Amendment No. 86
License No. DPR-32

Amendment No. 87
License No. DPR-37

ATTACHMENT TO LICENSE AMENDMENTS

SAFETY EVALUATION BY THE OFFICE OF NUCLEAR REACTOR REGULATION
RELATED TO AMENDMENT NO. 86 TO FACILITY OPERATING LICENSE NO. DPR-32
AND AMENDMENT NO. 87 TO FACILITY OPERATING LICENSE NO. DPR-37
VIRGINIA ELECTRIC AND POWER COMPANY
SURRY POWER STATION, UNIT NOS. 1 AND 2
DOCKET NOS. 50-280 AND 50-281

FIGURE 2.1-1 REACTOR CORE THERMAL & HYDRAULIC SAFETY LIMITS-
THREE LOOP OPERATION, 100% FLOW

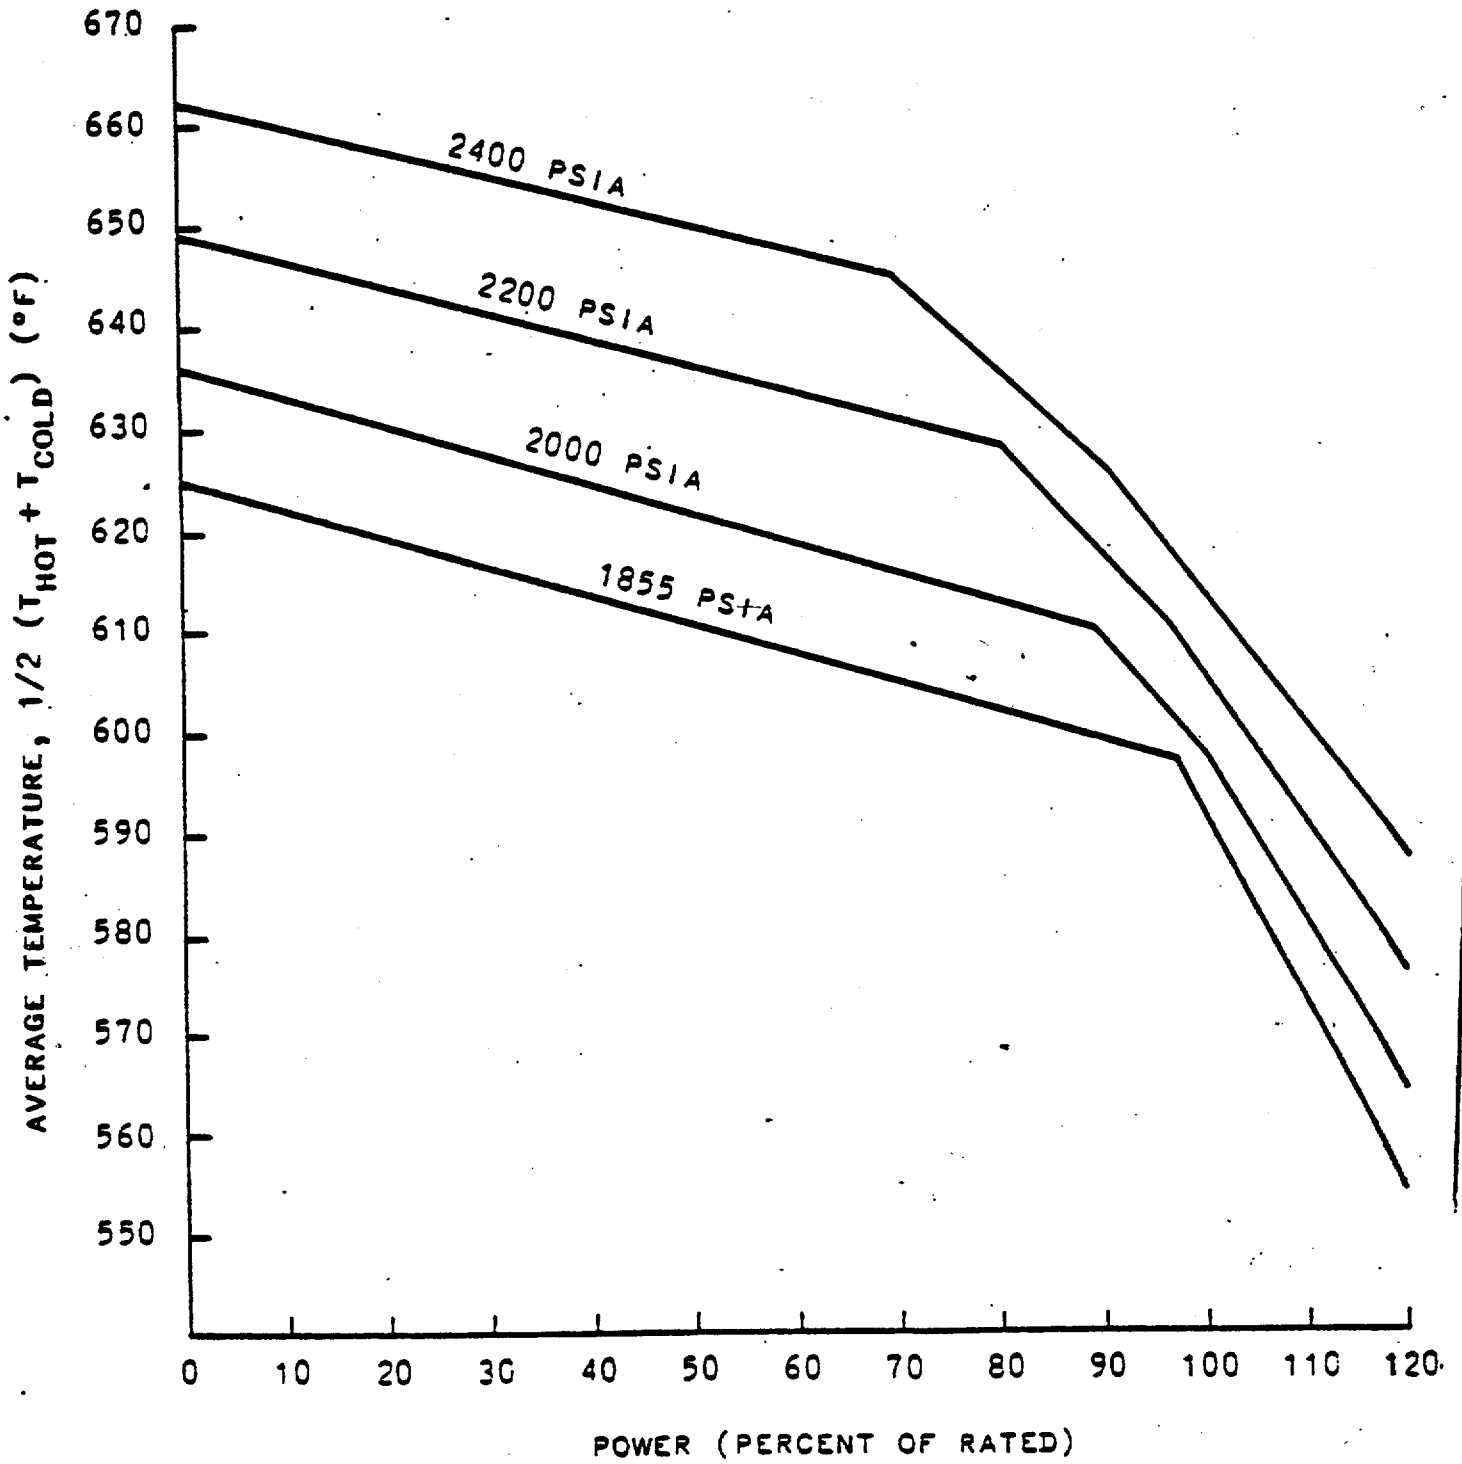
These amendments revise the Technical Specifications to restore the core thermal limits and overtemperature and overpower ΔT setpoints to values consistent with 100% of thermal design flow.

The curves of TS Figure 2.1-1 which show the allowable power level decreasing with increasing temperature at selected pressures for constant flow (three loop operation) represent limits equal to, or more conservative than, the loci of points of thermal power, coolant system average temperature, and coolant system pressure for which the DNB ratio is equal to 1.30 or the average enthalpy at the exit of the core is equal to the saturation value. The area where clad integrity is assured is below these lines. The temperature limits are considerably more conservative than would be required if they were based upon a minimum DNB ratio of 1.30 alone but are such that the plant conditions required to violate the limits are precluded by the self-actuated safety valves on the steam generators. The three loop operation safety limit curve has been revised to allow for heat flux peaking effects due to fuel densification and to apply to 100% of design flow. The effects of rod bowing are also considered in the DNBR analyses.

The revised limits and setpoints contained in the proposed Technical Specification changes (Ref. 2) are consistent with the FSAR assumption of 100% of thermal design flow, and are identical to those provided in Reference 3. These were the previously applicable limits and setpoints in effect prior to the Reference 1 submittal. Since the proposed limits and setpoints are identical to those previously analyzed and have been checked for current fuel cycle conditions, and since the thermal design flows have been experimentally verified, operation with the proposed Technical Specification changes will not invalidate any existing safety analyses for Surry Units 1 and 2.

We have reviewed the core thermal limits and overtemperature and overpower ΔT setpoints provided in References 2 and 3 and concur with the licensee's assessment that these limits and setpoints are identical and therefore no accident reanalysis is required for the proposed changes in the Technical Specifications.
